This is an electronic copy of my preliminary comments regarding the Section 106 review for the Permanent WTC PATH Station. A hard copy was forwarded last week. Thannk you.

Comments of New York State Senator Seymour P. Lachman on the Permanent World Trade Center PATH Terminal Draft Environmental Impact Statement and Section 4(f) Evaluation July 21, 2004

Response of the Lower Manhattan Emergency Preservation Fund to the Permanent WTC PATH Terminal Draft Environmental Impact Statement (DEIS).

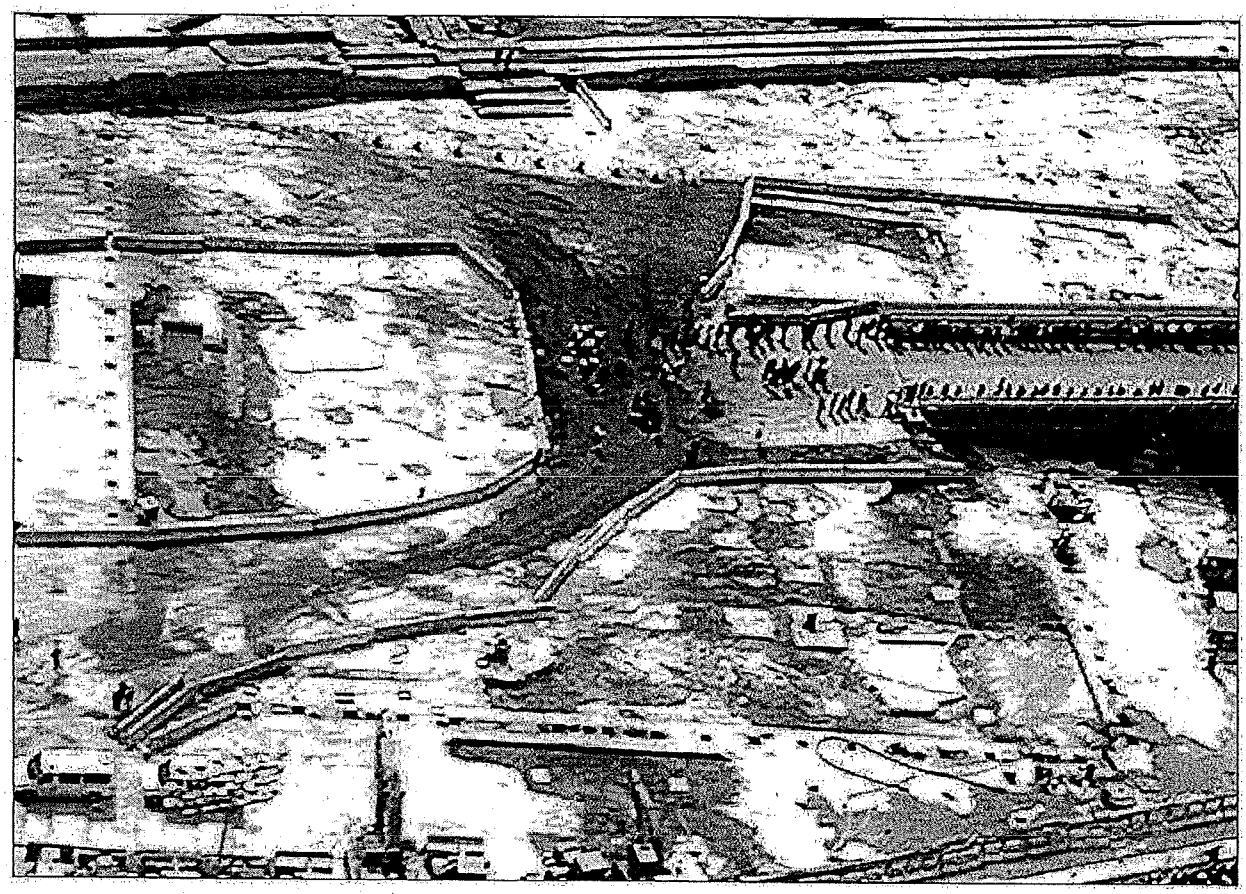
Daniel Libeskind has described the preservation of the "BEDROCK FOOTPRINTS," the heart and soul of his original scheme, as, "REVEALING THE HEROIC FOUNDATIONS OF DEMOCRACY FOR ALL TO SEE." The attacks of September 11, 2001 sent the towers crashing to earth, but in the profound depth of the World Trade Center site these foundations remained, embodied in the steel column bases, concrete and bedrock of the tower footprints, a monument to the endurance of our nation and a national shrine for ages to come.

For more than two years the tower footprints have been hidden beneath fill while temporary construction projects progressed. There was an initial focus on the tower footprints: the Libeskind design was organized around the footprints, and the temporary PATH station did not encroach. Governor George Pataki said that where the towers stood was sacred ground and pledged that we would never build where the towers stood.

1. Clean materials sufficiently that size, color, texture and material of each component is apparent, i.e. steel, concrete, bedrock. It is feared that machine brushing alone may leave components covered with dust or residue that will mask their character.

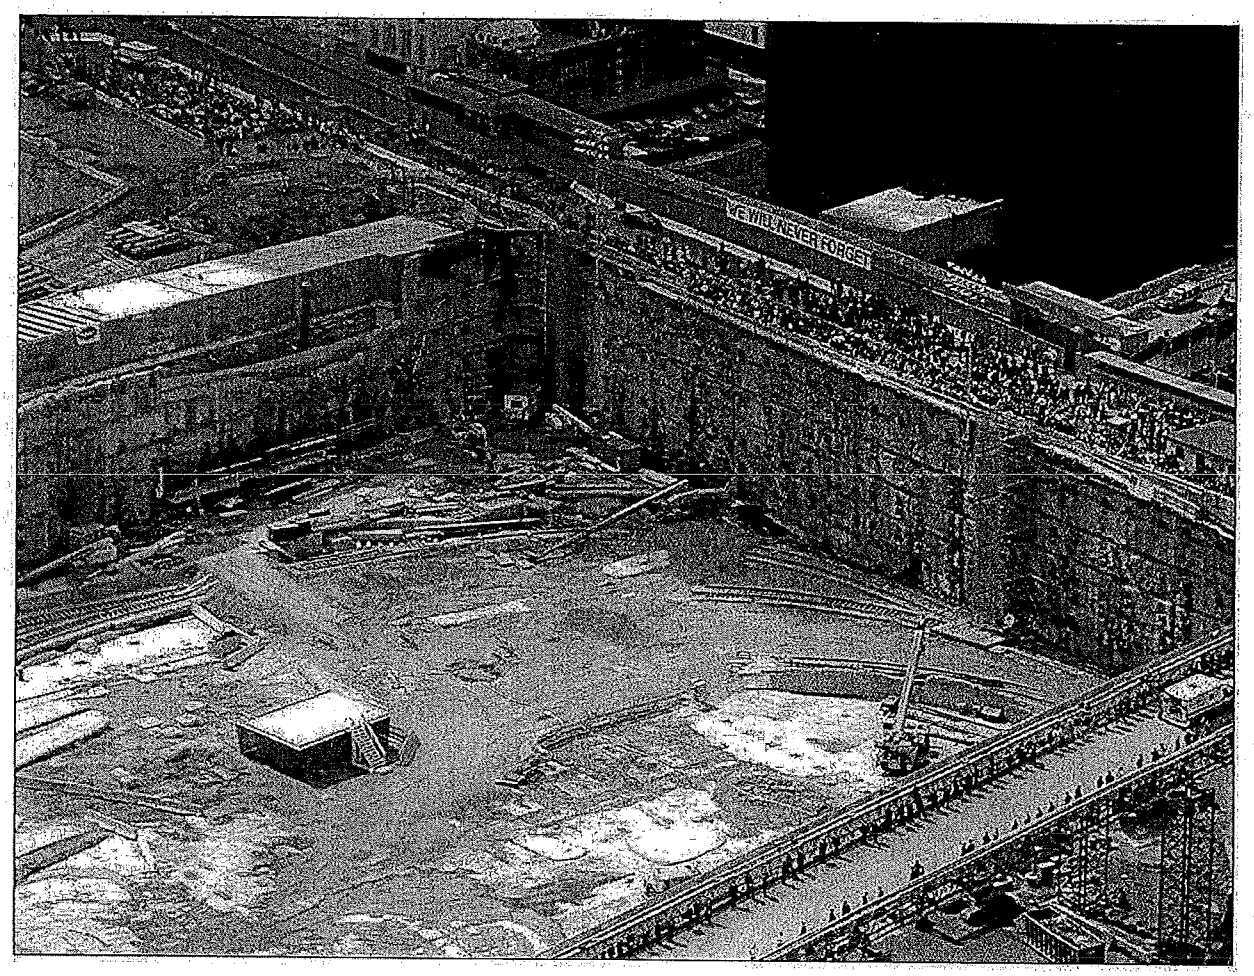
2. Remove fill, new concrete rat slabs and other foreign materials sufficiently to permit the ruin to be seen in full relief, i.e. revealing various levels of concrete slabs, edges

of column bases and damaged slabs, recesses within column bases, and areas where stone of the underlying bedrock is revealed. It is feared that the methods employed may leave the footprints looking flat and featureless which would be entirely misleading.
